AR-07-1162

Southern Nuclear Operating Company
Vogtle Early Site Permit Application
Supplemental Response to Requests for Additional Information on Geology/Seismology

**Supplemental Response to Geology/Seismology RAIs
on the
Vogtle ESP Application**

Figure 1g. Quadratic fit to the amplification values for 0.5 Hz.

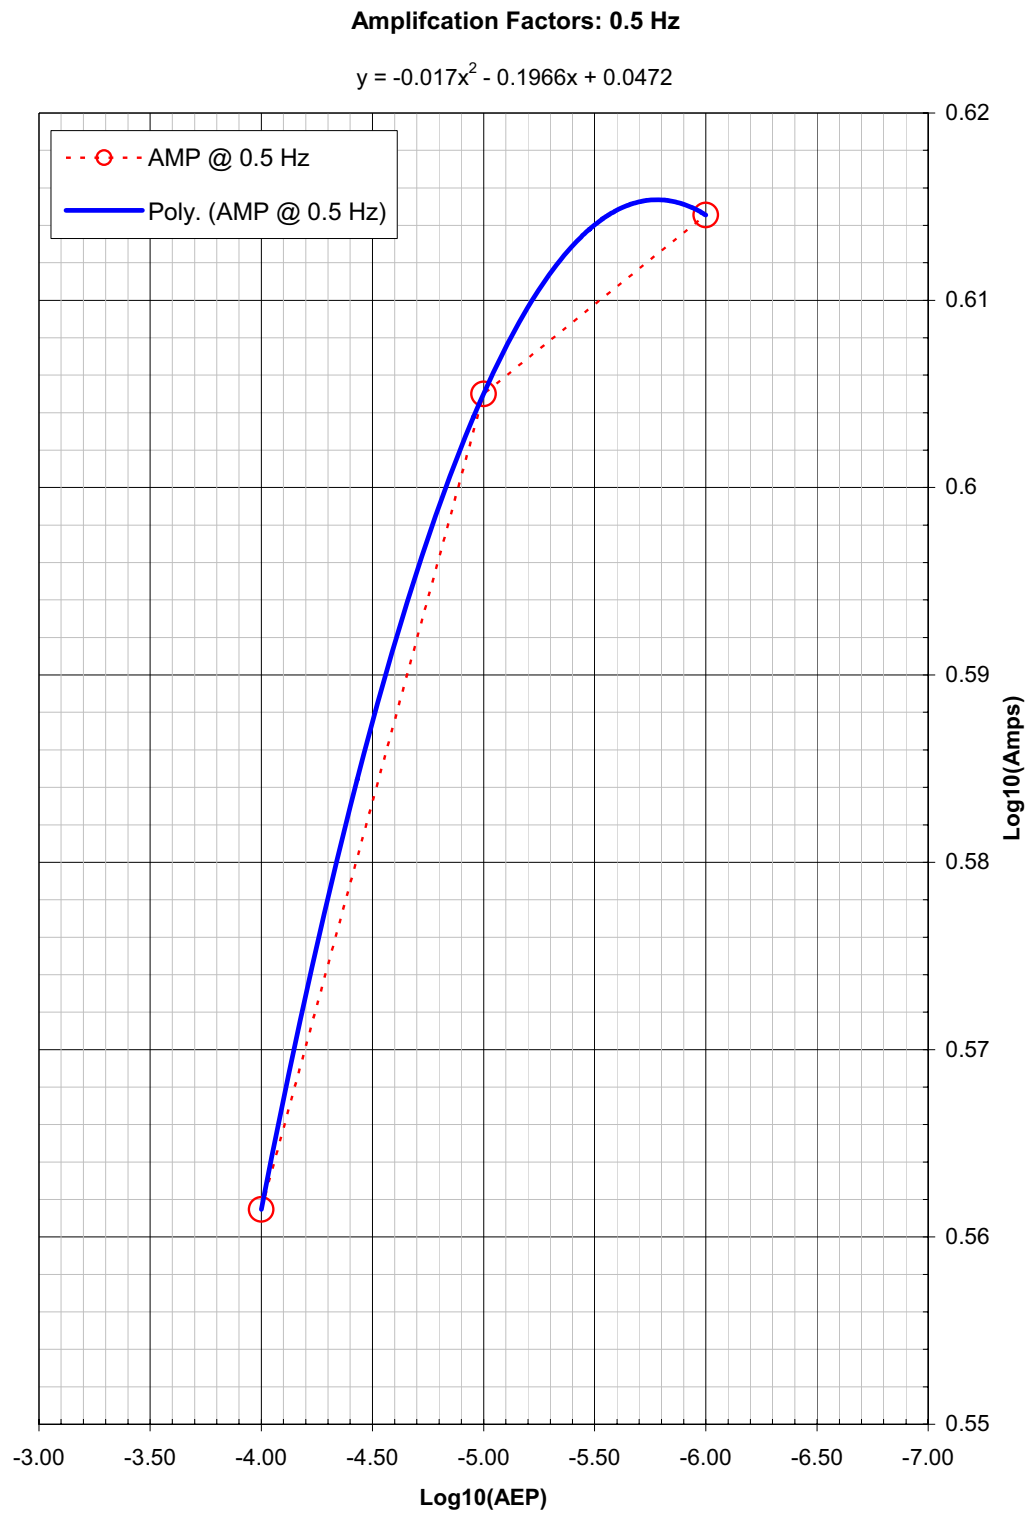
2.5.2-3 In response to this RAI, soil hazard curves were provided at three annual exceedence frequencies (10^{-4} , 10^{-5} , and 10^{-6}). However, in order for the staff to verify the adequacy of the SSE, soil hazard curves are requested at additional annual exceedence frequencies (i.e. at values between 10^{-4} , 10^{-5} , and 10^{-6}).

For each of the seven frequencies a quadratic equation was fit to the log (base10) of the spectral ratios (AMP) as a function of the log (base10) of the annual exceedence probability (AEP). Mathematically, this functional model is given as,

The resulting fits to the three data points are shown in Figure 1, located on the following pages, for each of the seven frequencies. The coefficients and equation are given at the top of each plot. Note that the red dashed line is a linear log-log line between the three data points.

Figure 2.5.2-18A: Seismicity in southeastern US and areas used to examine seismicity effects.

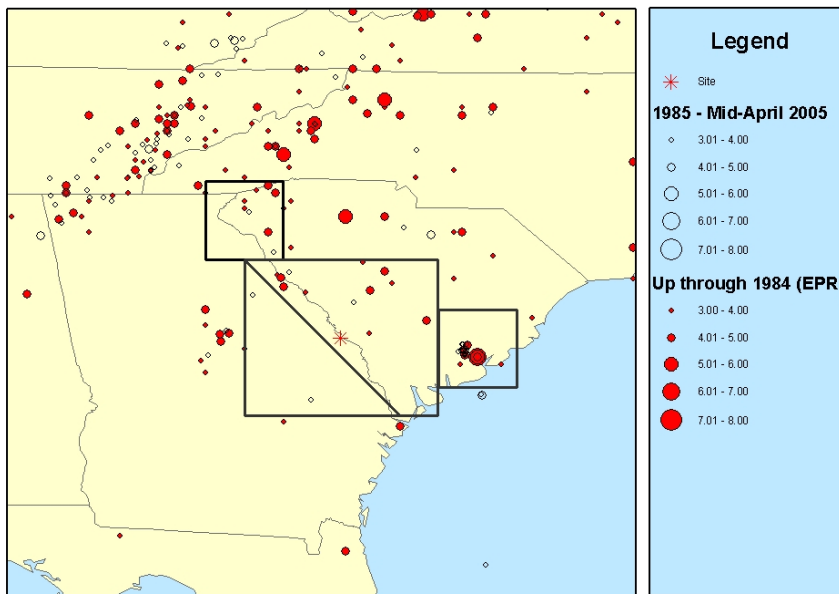
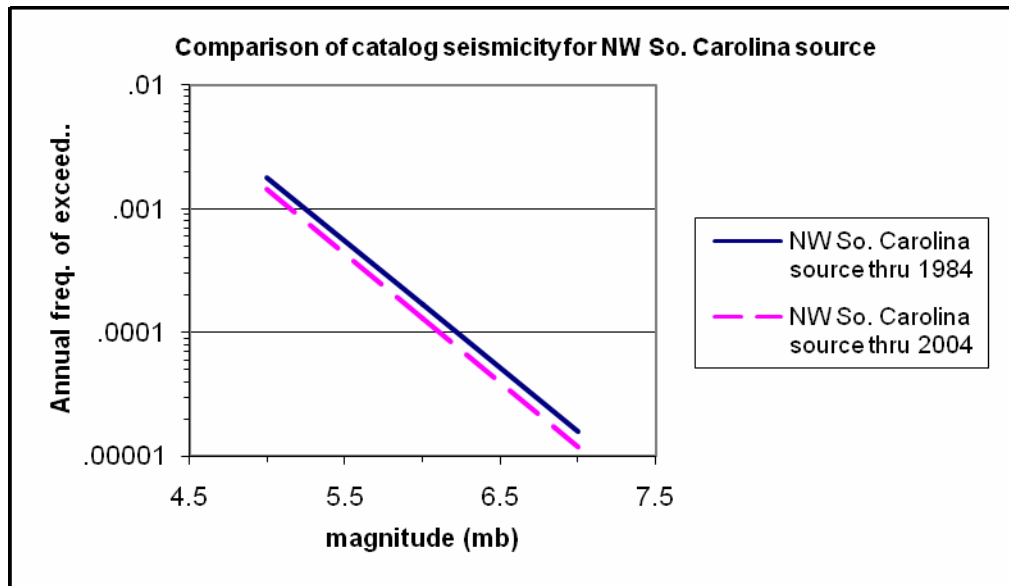
2.5.2-18 Please provide justification for the selection of the geometries shown in SSAR Figure 2.5.2-16 as well as RAI Figure 2.5.2-18A. Specifically, why were these particular geometries selected over other possible geometries? In addition, please justify the exclusion of the recent seismicity associated with the Helena Banks fault zone from all of the selected geometries.

Several areas were used to examine the effect of the new regional earthquake catalog. RAI figure 2.5.2-18A shows these areas. The areas were selected because sensitivity studies showed that seismic sources in the vicinity of the site, in the Charleston, South Carolina region, and in northwestern South Carolina were the main contributors to seismic hazard at the Vogtle site. The large rectangular source surrounding the site spans 2.5° longitude by 2° latitude, the source representing Charleston, South Carolina, spans 1° longitude by 1° latitude, and the source in northwestern South Carolina spans 1° longitude by 1° latitude. These sources were selected as representative of the regions important to seismic hazard analysis. In addition, the large source surrounding the site was divided with a diagonal line to capture seismicity in the northeast half of the source, so that seismicity would not be combined with the relatively aseismic, southwest half of the source.

All four regions showed the same result, that additional seismicity from 1985 to mid-2004 does not increase estimated activity rates in the area around the Vogtle site. As an example, RAI Figure 2.5.2-18B shows the effect of additional seismicity in the square, northwestern South Carolina source shown in RAI Figure 2.5.2-18A. The estimated activity rate decreases, similar to what is shown in SSAR Figure 2.5.2-18. We conclude that any region in South Carolina that would affect the seismic hazard of Vogtle would have estimated activity rates that stay constant or decrease, if the new regional earthquake catalog were added to the analysis.

The seismicity in the area of the Helena Banks fault zone was not considered separately because low-magnitude seismicity offshore would not contribute significantly to seismic hazard at the Vogtle site. As an example, the low-magnitude seismicity in the Charleston region is modeled in the seismic hazard calculations with an exponential magnitude distribution using the EPRI-SOG team interpretations of seismicity rates. The seismic hazard from this model is negligible compared to the seismic hazard from the large-magnitude, characteristic model of earthquakes in the Charleston region.

SSAR Figure 2.5.2-37 Typical Results of Spectral Amplification at 86-ft Depth (Top of Blue Bluff Marl) Using EPRI Degradation Curves for High Frequency Time Histories of 10^{-4} MAFE Input Motion Level

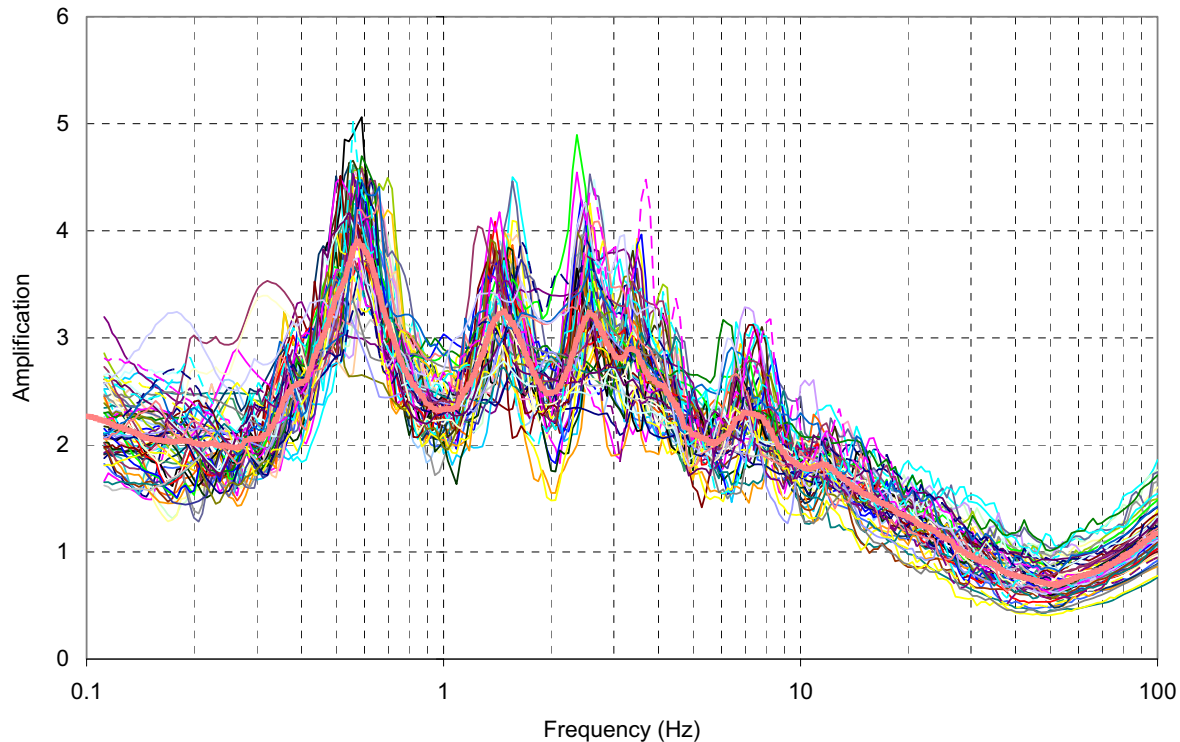
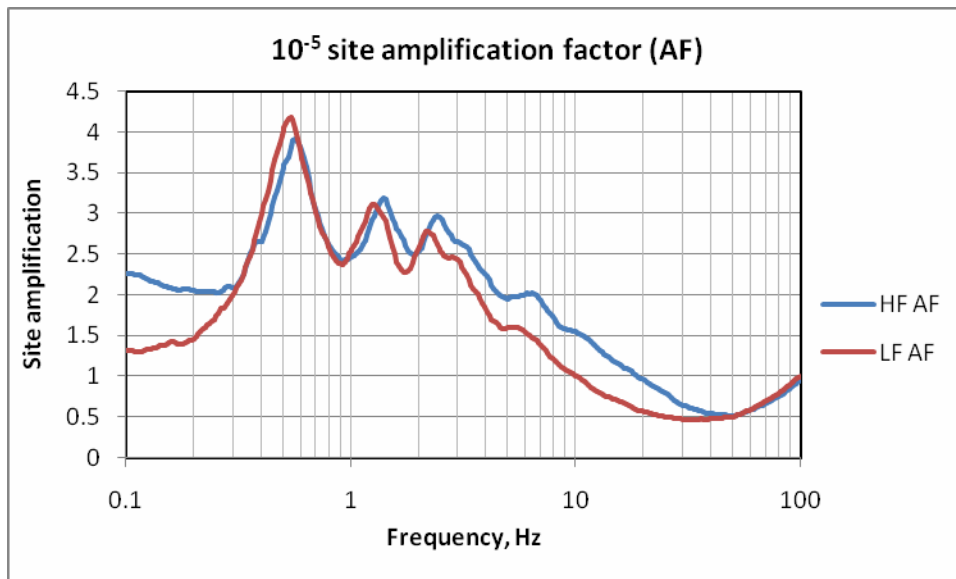
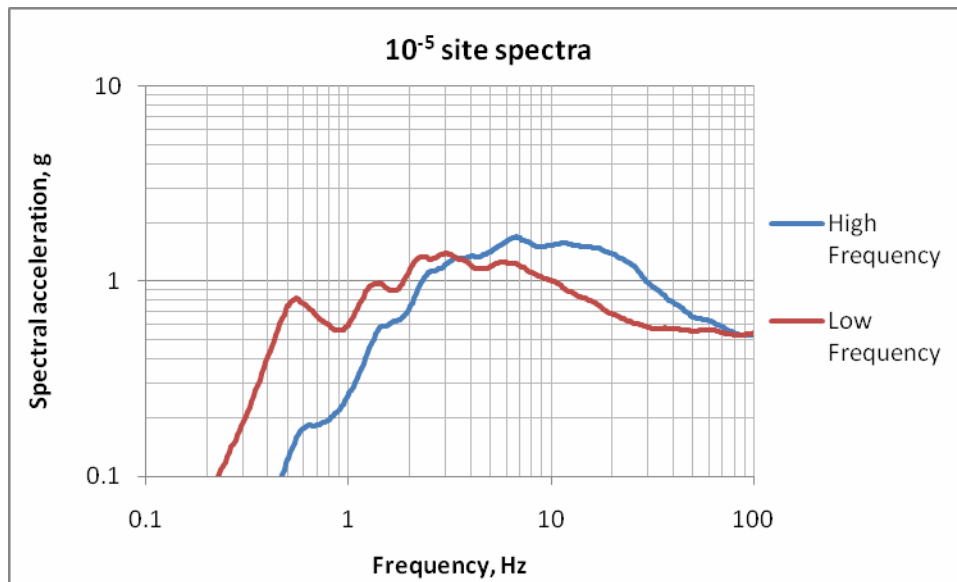
2.5.2-19 Supplement the RAI with additional information related to STEP 5. Please include a definition, and a figure (or table), of the envelope motion. The response to this RAI states

However, it is not clear if the envelope motion refers to the envelope of the mean AFs or envelope of the mean response spectra at the control point.

SSAR Figure 2.5.2-37, repeated below, illustrates the 60 individual AFs and the logarithmic mean AF across the frequency range of 0.1 Hz to 100 Hz, for the 10^{-4} MAFE, HF input, EPRI mean material curves, and 86' depth.

STEP 5B: The mean AFs for the EPRI and SRS material curves are equally weighted, to give 6 mean AFs across the frequency range 0.1 Hz to 100 Hz, for the control point horizon. These 6 mean AFs correspond to the 3 ground motion levels and to the HF and LF input motions.

STEP 5C: The controlling HF or LF input motion is determined over the frequency range 0.1 Hz to 100 Hz for each MAFE, by examining the envelope of soil response spectra at the control point location (86' depth) due to the HF and LF rock motion. Figure 2.5.2-Y1 gives an example of logarithmic mean amplification factor as a function of frequency for the control point location for the HF and LF 10^{-5} motion. Figure 2.5.2-Y2 gives an example of the resulting 10^{-5} site response spectra calculated by multiplying the 10^{-5} input rock motion by the logarithmic mean AF values from Figure 2.5.2-Y1. Note from Figure 2.4.2-Y1 that at very low frequencies the HF amplification factor exceeds the LF amplification factor, because the HF input rock motion does not include much low-frequency content (the denominator of the ratio of site response divided by rock input motion is low). Figure 2.5.2-Y2 shows that, at high frequencies, the HF site response spectrum equals or exceeds the LF site response spectrum and at low frequencies, the reverse is true. This means that the HF input rock motion will control the high frequencies (above 8 Hz) soil responses and the LF input rock motion will control the low frequencies soil responses (below 2 Hz). In between, the controlling motion, which is the maximum soil response, depends on the MAFE and the frequency. This step results in one set of mean AFs (across the frequency range 0.1 Hz to 100 Hz) for each MAFE.
